CASE#: C15-2015-0089  
Address: 1704 W 10TH ST

**CITY OF AUSTIN  
APPLICATION TO BOARD OF ADJUSTMENT  
GENERAL VARIANCE/PARKING VARIANCE**

STREET ADDRESS: 1704 W 10th Street, Austin TX 78703

# Master Comment Report

## 1 SITE PLAN

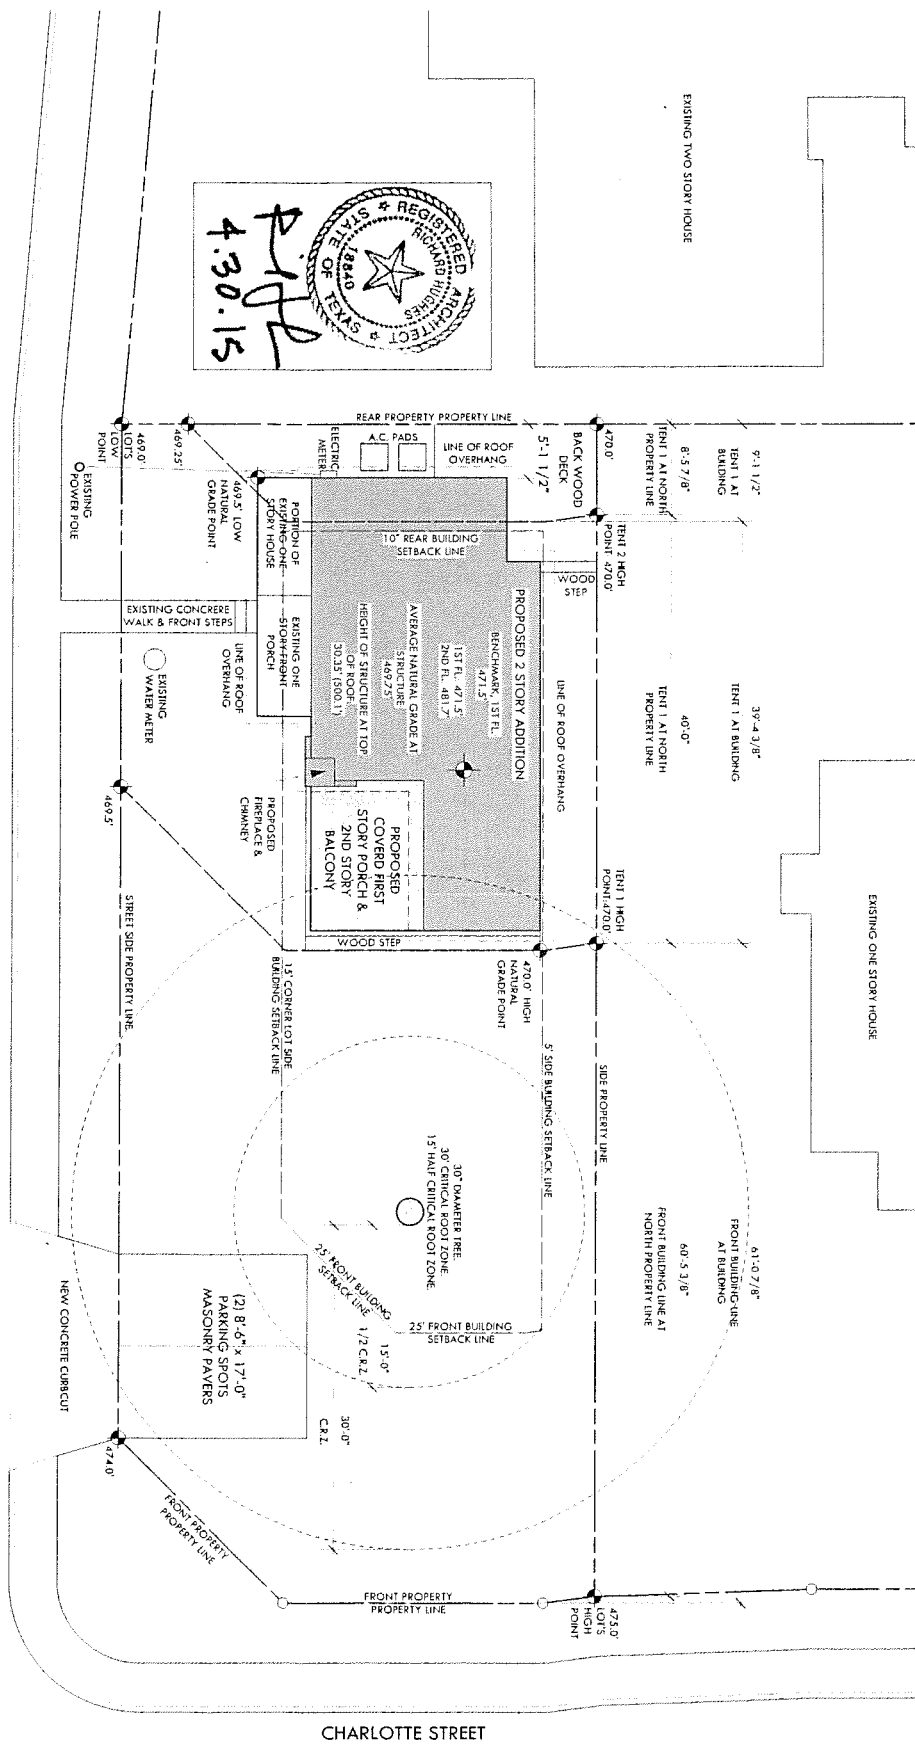
3. The proposed new type 1 apron (its location) does not comply with the Transportation technical criteria manual. See Transportation TCM Section 5.3.1.J - Type 1 driveways are to be located no closer to the corner of intersecting rights of way than 60 percent of parcel frontage or 50 feet, whichever is less. ~~Revisions required.~~

4. Applicant submitted on Page 1 of the PR application that the lot size is 4,384sf - this is what TCAD has - this is not always accurate. Per Plot plan - it looks like about 4,683sf and per COA GIS - it looks to be about 3,476sf.

6. Staff will not approve a plot plan that I cannot verify setbacks on without a Scaled Source survey with metes and bounds that match up with the requested source survey.

7. As submitted, the plot plan is providing spot elevations between 469' and 475' - my GIS 2012 contour don't match up. Thus, this is why I am requesting a Source Survey with 1' contours and a benchmark or TBM to verify your topo data and Sub-Chapter F compliance exhibits.

8. As submitted, the plot plan has no metes and bounds on it - this is required. Thus, I am requesting a Source survey.
9. As submitted, the plot plan does not depict or an additional exhibit was not provided for with the submittal to demonstrate where the existing structure is and its exact location for staff to complete a review for compliance with 25-2-963. Thus, cannot provide comments at this time.

### 3 NORTH ELEVATION

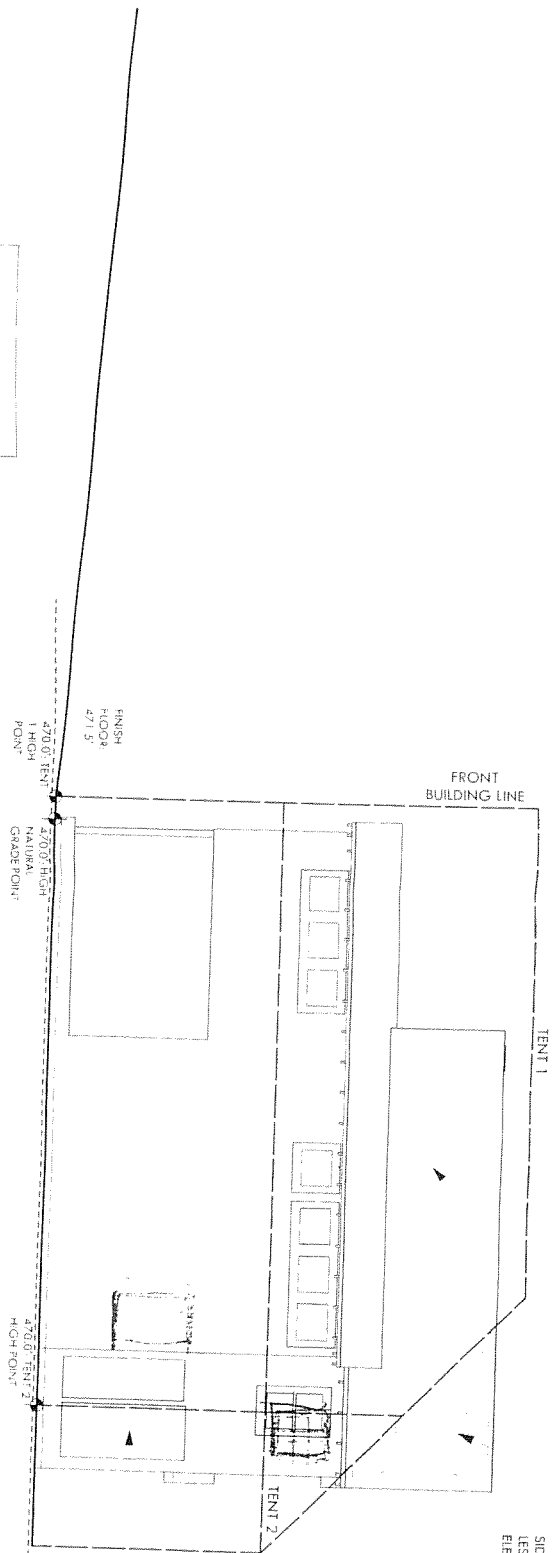
11. All new 2<sup>nd</sup> and 3<sup>rd</sup> (habitable attic) must comply with setbacks or Board of Adjustment Variance will be required.
12. Your claiming an Attic Exemption but no Habitable Attic exhibits were submitted that demonstrate compliance with BOA Interpretation C15-2011-0110 - Motion sheet dated January 9<sup>th</sup> 2012. At minimum - A scaled Section and floor plan must be submitted along with the calculation of the area with Ceiling Heights between 5 feet and just less than 7 feet and the area with Ceiling Heights over 7 feet. You must demonstrate that your attic has a complying ratio. Note: the Building Criteria Manual Online discusses this and outlines what is required. Exhibits must be Scaled, signed and dated. Submit with your next Update within the plan set.

13. Dimension (font size of text) on the floor plans is not legible and is unacceptable - revise accordingly.
14. No shed or gable roof projections are allowed within the Rear Setback plane. They are only allowed within the Side Setback planes. Substantial revisions are required or a Board of Adjustment Variance will be required.

## 2 DEMO. PLAN

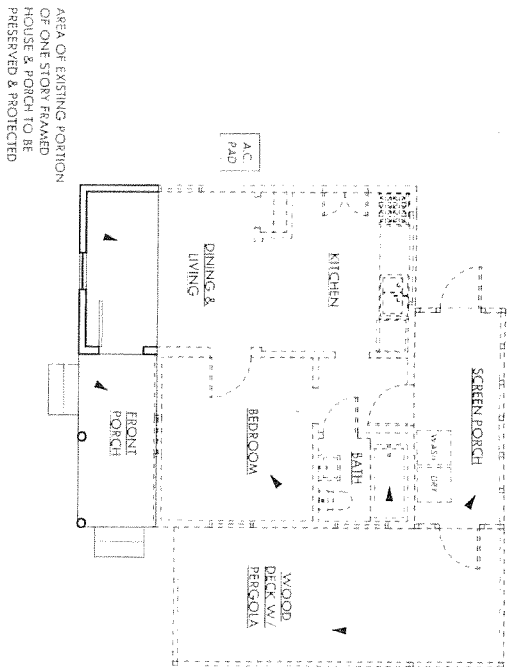
10. Per Demolition plan and using Google Street view - what you are proposing to demolish (noncomplying setback s) and build back does not comply with 25-2-963. (Once you demolish a noncomplying wall or any portion of it - you must comply with the applicable rear, street side yard, or interior side yard setbacks. Board of Adjustment Variances will be required or substantial revisions will be needed.
